Access Compliance Report

Public Rights-of-Way

| Intersection ID: 32312 | Main Street: CAMBRIDGE_WOODS_CT | Cross Street: TRAVIS_GULCH_DR | Location: SE |
| ADA ID: 31B12D2BE7A9 | Ramp Type: BlendTrans1 | Initial Pass/Fail: Fail | Overall Compliance: No |

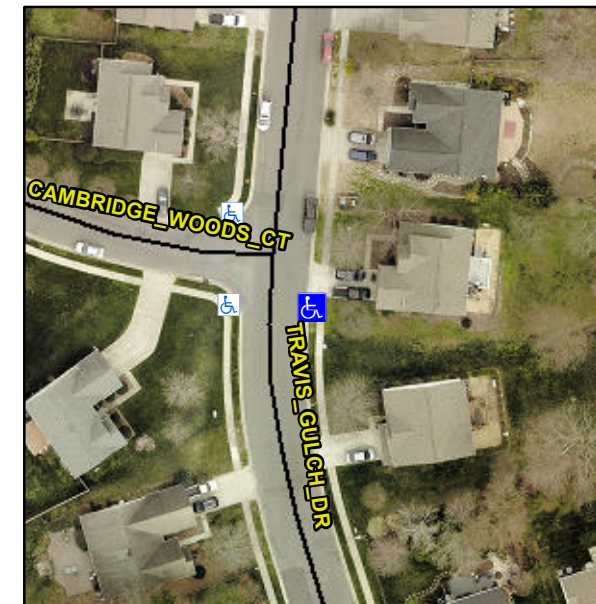
Not Found, R304.5.1

| Compliance | Description | Data | Compliance | Description | Data |
|------------|-----------------------|------|------------|-----------------------------|------|
| No | Ramp Width (in) | 39.0 | Yes | BlendTrans XSlope (%) | 1.2 |
| | | | No | Curb Slope (%) | 9.6 |

Remove & Replace Curb Ramp With Two New Directional Ramps or Equivalent.
